Re: Powertech Dewey-Burdock Project,
Docket 040-09075, Custer and Fall River
County, South Dakota

This letter is to provide environmental comments on your March 15, 2010, letter regarding the above referenced project which proposes granting a radioactive source materials license to develop and operate the Dewey-Burdock *in-situ* recovery facility near Edgemont, South Dakota. The Powertech Dewey-Burdock Project is proposed within portions of Sections 1-5, 10-12, 14 and 15, Township 7 South, Range 1 East, Fall River County, South Dakota, and Sections 20, 21, and 27-35, Township 6 South, Range 1 East, Custer County, South Dakota.

Initial Mine Unit

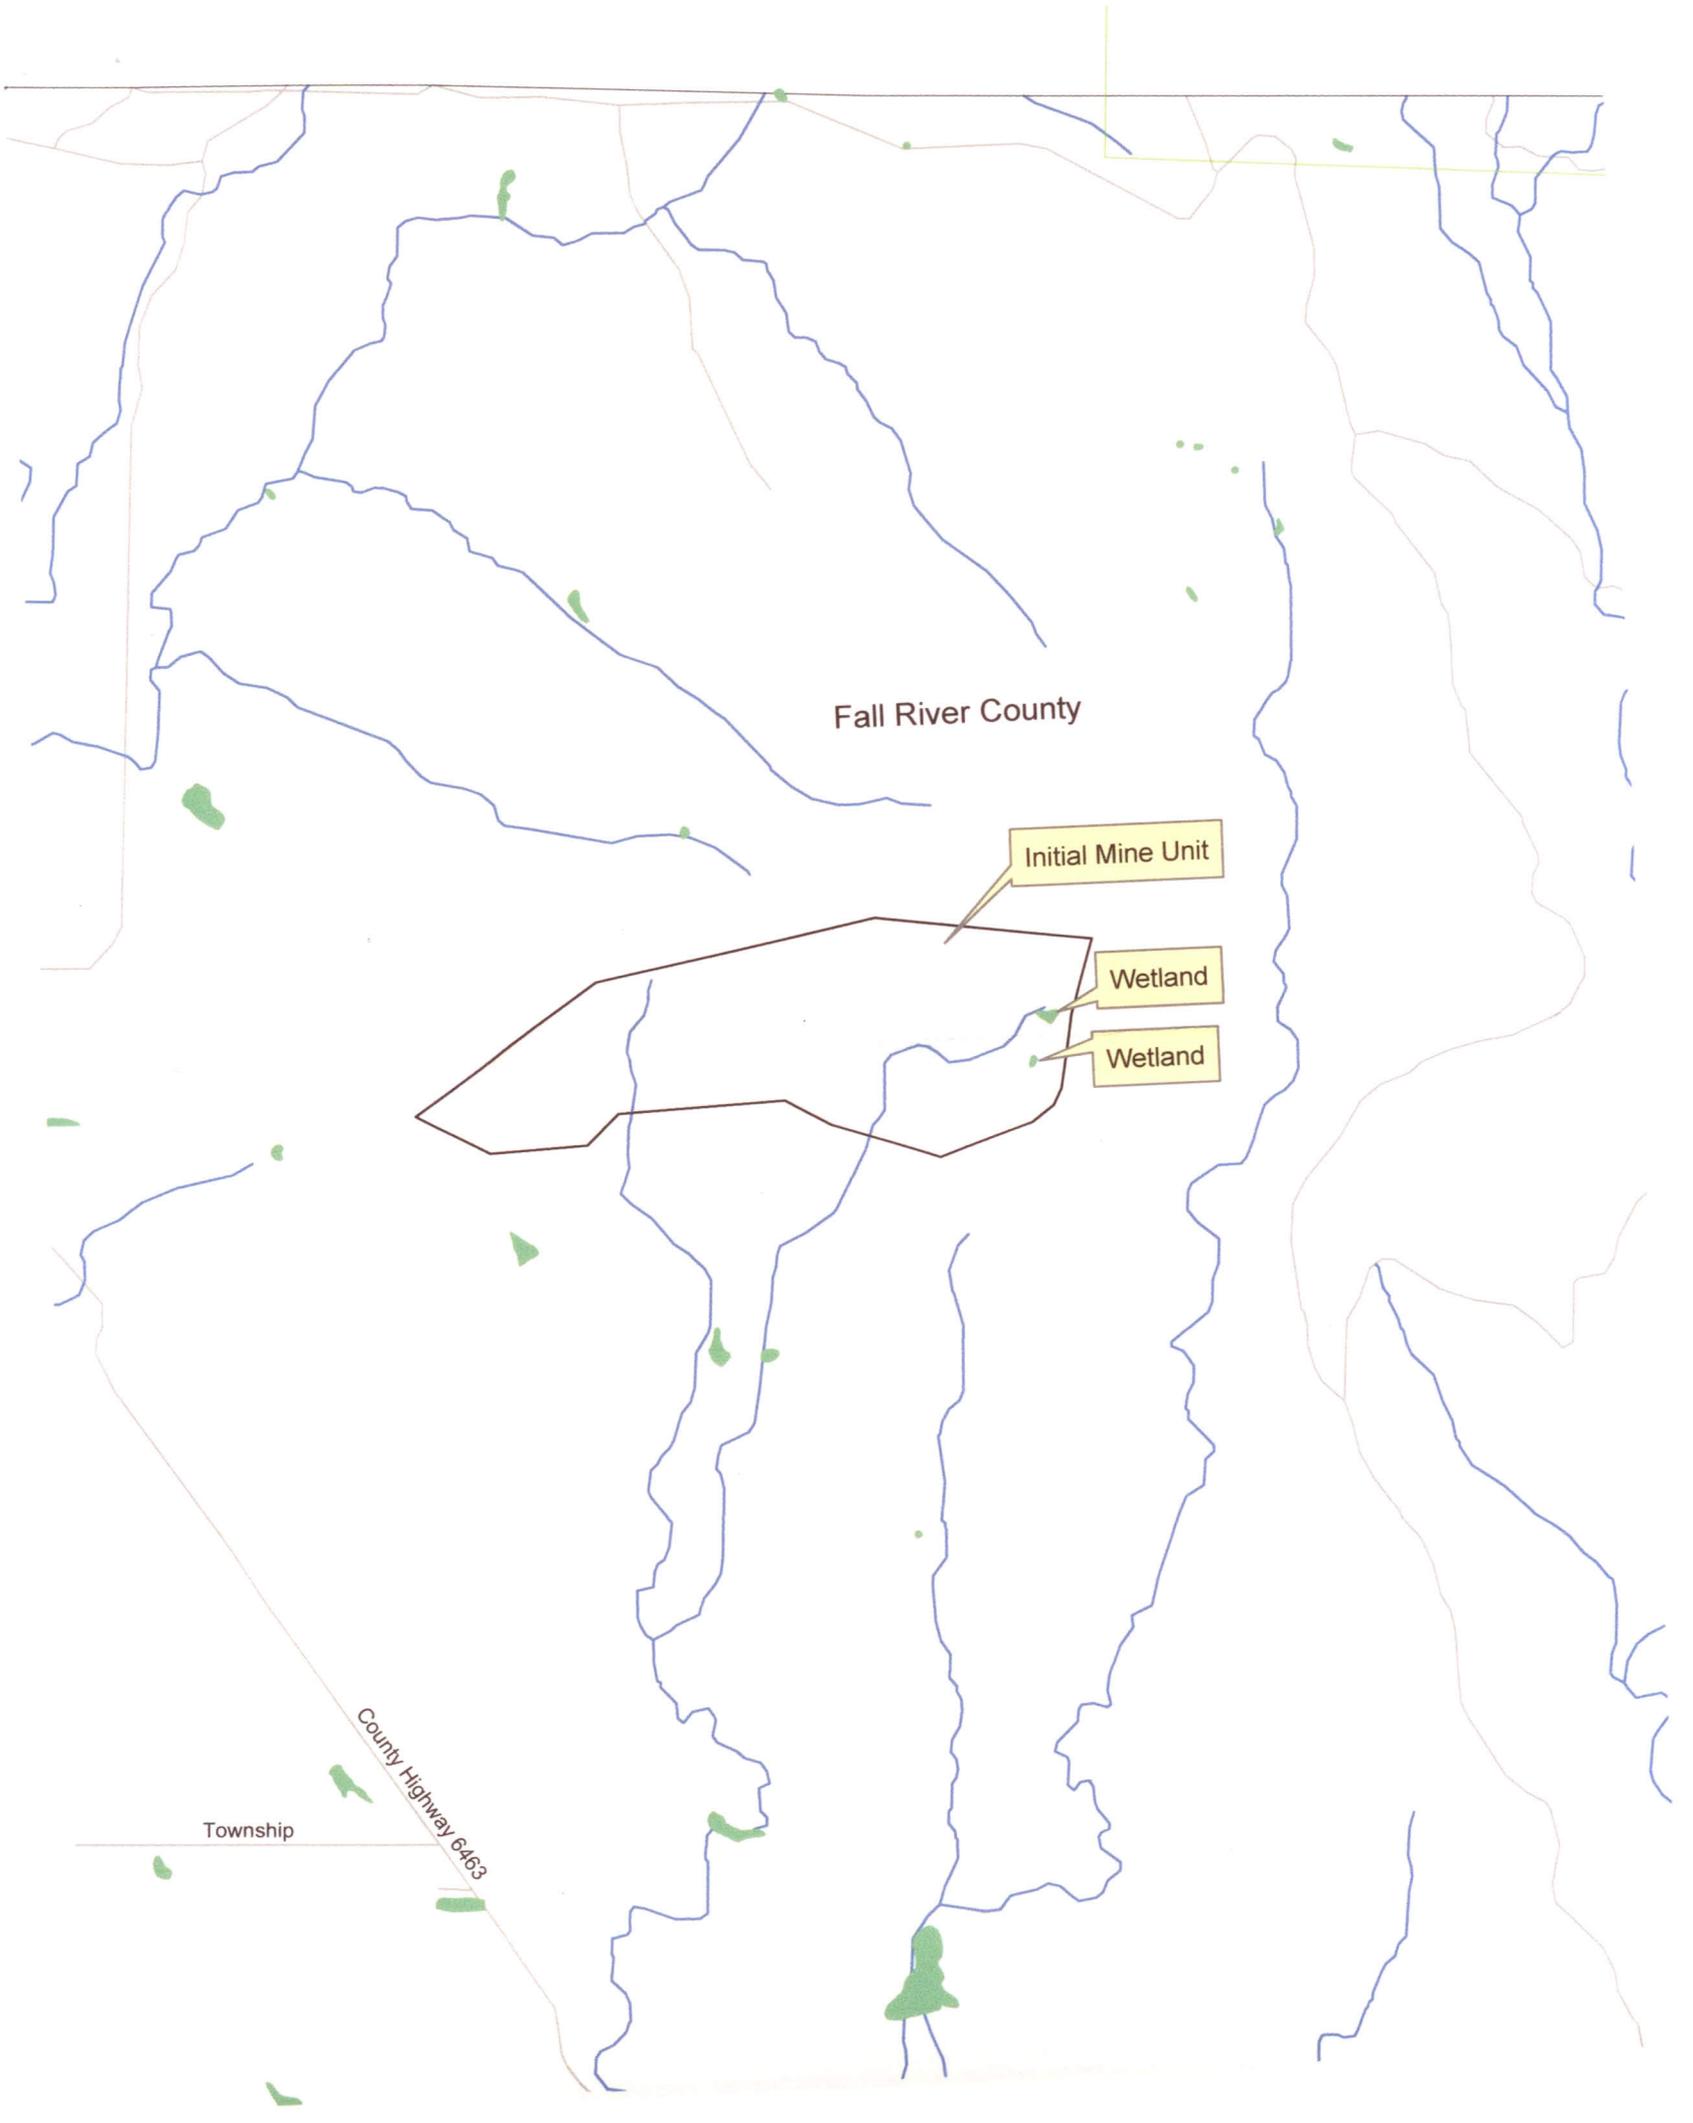
The National Wetlands Inventory indicates that numerous wetlands exist within the proposed permit boundary area. Two maps are enclosed showing wetlands found within the two initial mine units. The locations of other wetlands within the proposed permit boundary can be accessed at <http://www.fws.gov/wetlands/Data/Mapper.html>.

The U.S. Fish and Wildlife Service (Service), in accordance with the National Environmental Policy Act of 1969 (42 U.S.C. 4321-4347) and other environmental laws and rules, recommends complete avoidance of these areas, if possible. If this is not possible, attempts should be made to minimize adverse impacts. Finally, if adverse impacts are unavoidable, then measures should be undertaken to replace the impacted areas.
